**Report to the Future Melbourne (Planning) Committee**

**Planning Application TP-2018-50  
River View House, 274-282 Flinders Street, Melbourne**

**6 March 2018**

**DELEGATED PLANNING APPLICATION REPORT**

DRAWING TITLE  
EXISTING FACADE PHOTOS

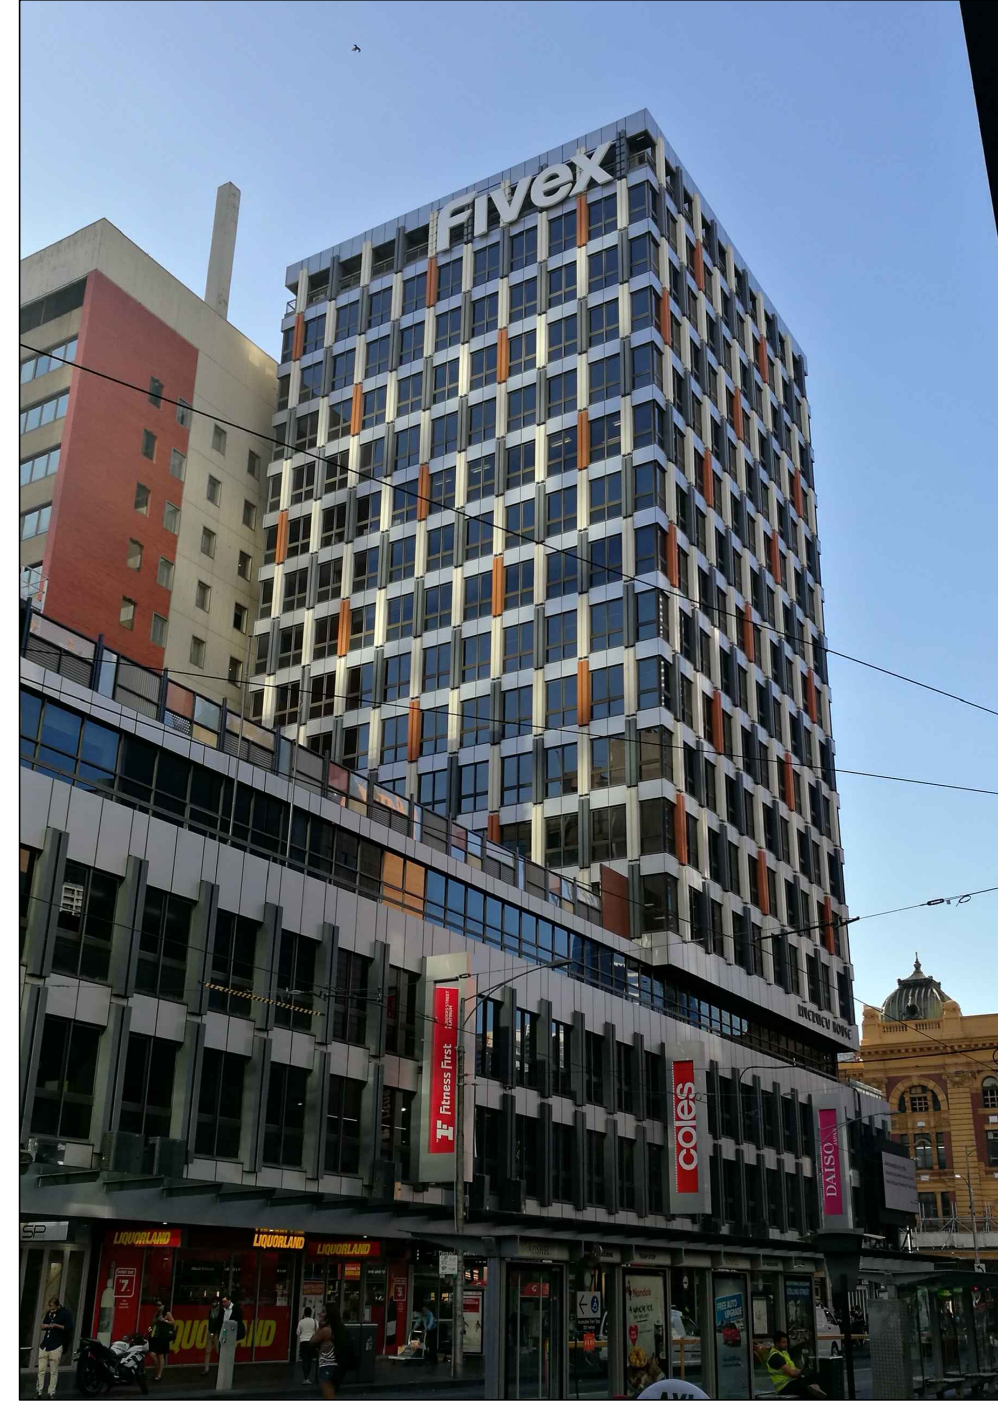
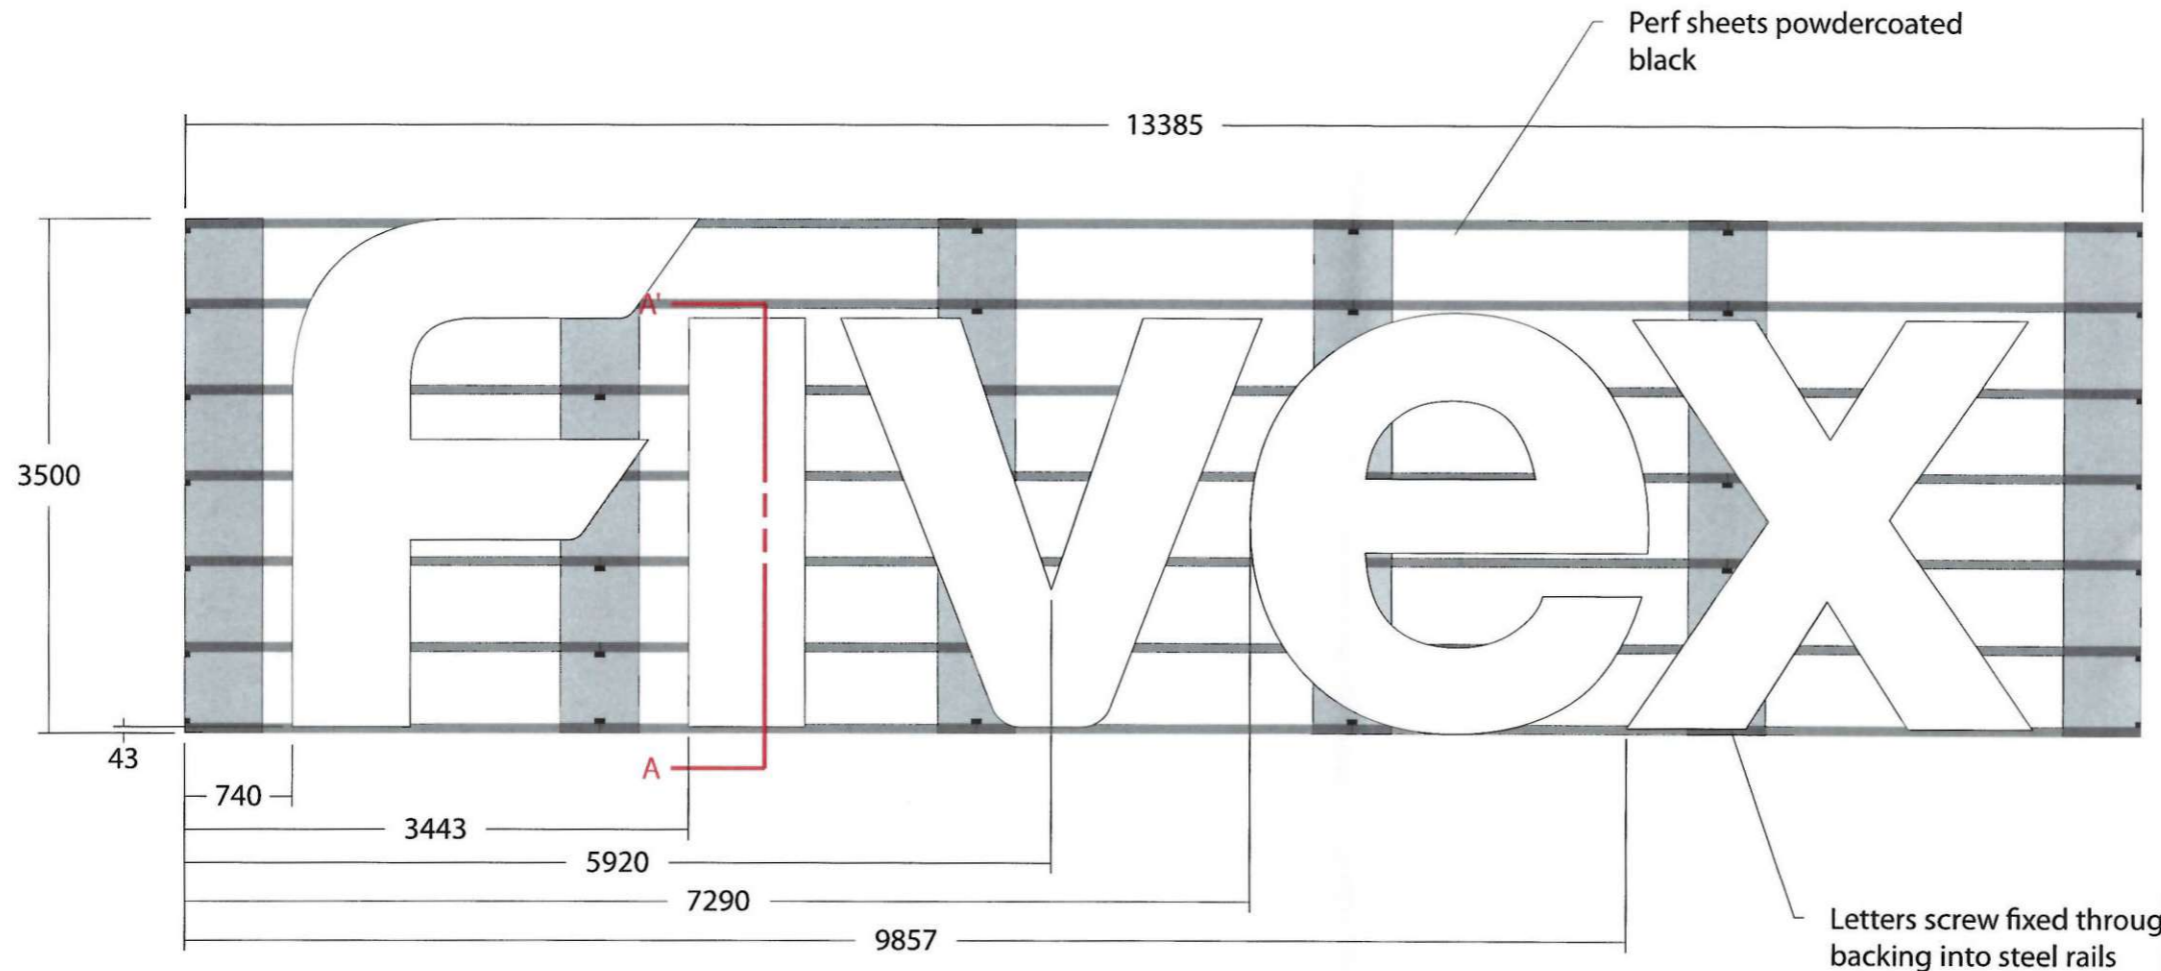
2. *The proposed electronic sign fails to appropriately integrate with the architectural features of the building, detracting from the strong gridded quality of the architectural expression of*

*the existing building, and would detrimentally impact on the city skyline when viewed from the public realm, failing to comply with the policies and advertising sign requirements of Clause 22.07 (Advertising Signs).*

- 3. The proposed electronic sign would read as visually obtrusive, and would be highly visible and distracting from the high amenity of public spaces along the Yarra River corridor, particularly Southbank Promenade and the Evan Walker Bridge, leading to an undesirable precedent that would detract from the Yarra River environs, failing to comply with the advertising sign requirements of Clause 22.07 (Advertising Signs) and Clause 52.05-3 (Advertising Signs).*

The proposed major promotional signs applied across the gridded features of the façade of the building, will detract from the architectural expression of the River View tower apartments by obscuring these elements from public view.

The failure of the design of the proposed sign to appropriately integrate with the architectural language of the host building will contribute to the sign reading as visually obtrusive within the façade of the building.

Figure 2 - Existing South Facing High-Wall Sign

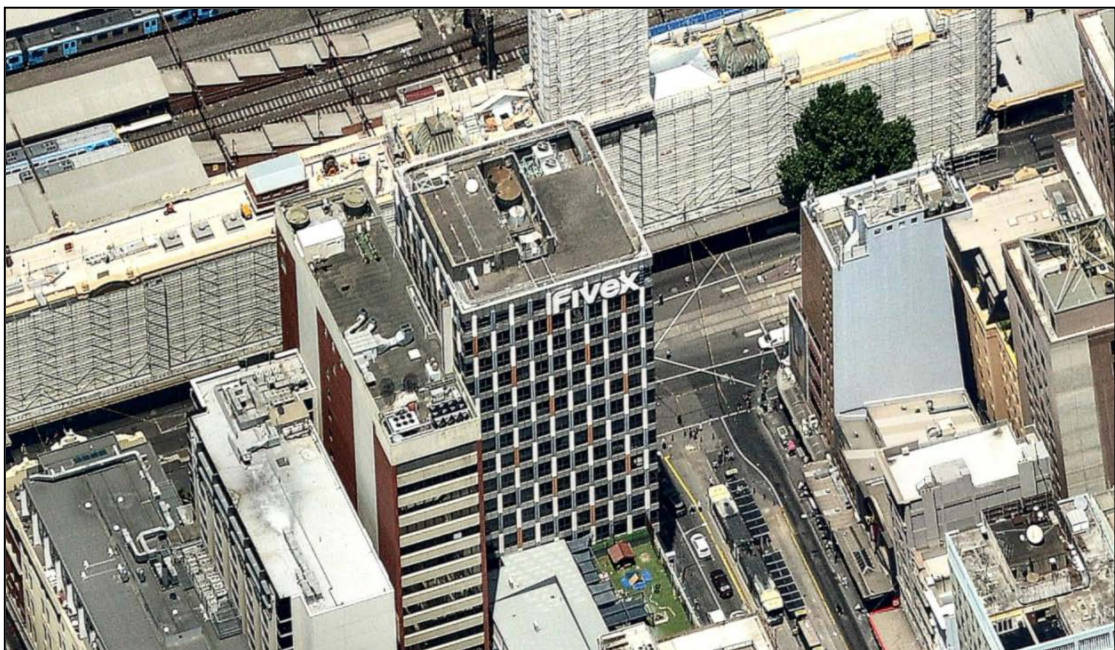
As demonstrated in the photographs provided with the application, the sign is highly visible above the south façade of Flinders Street Station from within the Yarra River Corridor.

It is considered that the sign in this location dominates Flinders Street Station when viewed from the Yarra River Corridor (particularly from Southbank Promenade), and detrimentally impacts the significance of the Flinders Gate historic precinct, described in Clause 22.04 as, "the City's southern face".

The southern facing major promotional sign has also been observed from within the Shrine of Remembrance forecourt.

The prominence of the south façade of the River View apartments tower when viewed from the Yarra River corridor and environs, given the signs location at the 'crown' of the tower, accentuates the visually obtrusive qualities of this sign, particularly when illuminated at night, will detrimentally impact on the city skyline when viewed from the public realm, particularly Southbank promenade and the Evan Walker Bridge.
